European Tyre and Rim Organisation

Brussels, 27 January 2005
TAL081-05-ETR-R117+30+54

ETRTO PROPOSALS FOR AMENDING REG. 117 AND REG. 30 & 54

- **PROPOSAL TO ADD TYRE ADHESION PERFORMANCES TO ECE REGULATION 117**
- **MULTIPLE TYPE APPROVAL NUMBERS ON TYRE SIDEWALLS**

“Example 4 (in application of paragraph 3.1.0.2)

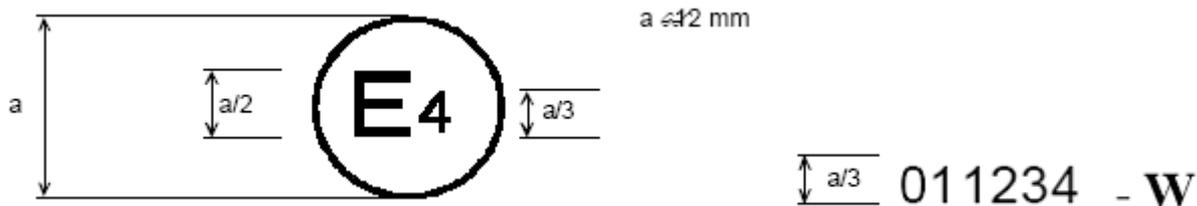
Annex 2 add a new example 4 as follows:

The above approval mark, affixed to a pneumatic tyre shows that the tyre concerned has been approved in the Netherlands (E4) pursuant to the requirements for adhesion performance level of tyres in rolling conditions on wet surfaces (-W) of Regulation No. 117 under approval number 011234.

The first two digits of the approval number indicate that, at the dates when the respective approval was granted, Regulation No. 117 included the 01 series of amendments relevant to the addition of ‘requirements for adhesion performance level of tyres in rolling conditions on wet surfaces.’”

“Example 5 (in application of paragraph 4.5)

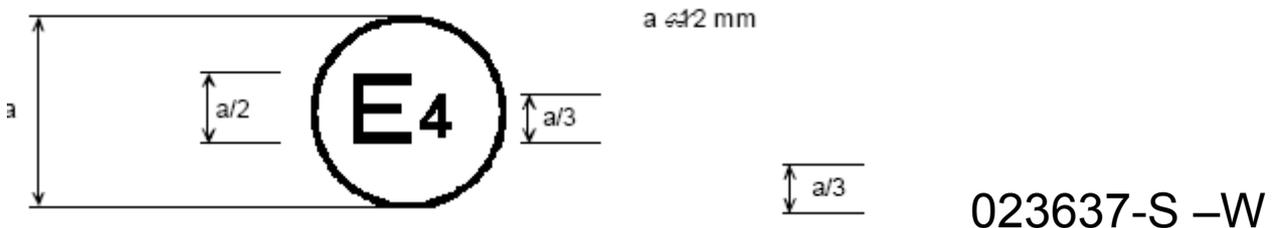
Annex 2 add a new example 5 as follows

The above approval mark, affixed to a pneumatic tyre shows that the tyre concerned has been approved in the Netherlands (E4) pursuant to Regulations No 30 with approval number 3637. The first two digits of the approval number indicate that, at the dates when the respective approval was granted, Regulation No. 30 included the 02 series of amendments.

The additional suffix “S” shows that approval to Regulation 30 has been extended (extension may be based either on own approval or on recognition of approval granted by another Contracting Party) by the Netherlands to include certification of conformity to this Regulation 117 for rolling sound emission levels. The additional suffix “-S” may be placed either after or just below the approval number.

The additional suffix “W” shows that approval to Regulation 30 has been extended (extension may be based either on own approval or on recognition of approval granted by another Contracting Party) by the Netherlands to include certification of conformity to this Regulation 117 for adhesion on wet surfaces. The additional suffix “-W” may be placed either after or just below the approval number.”
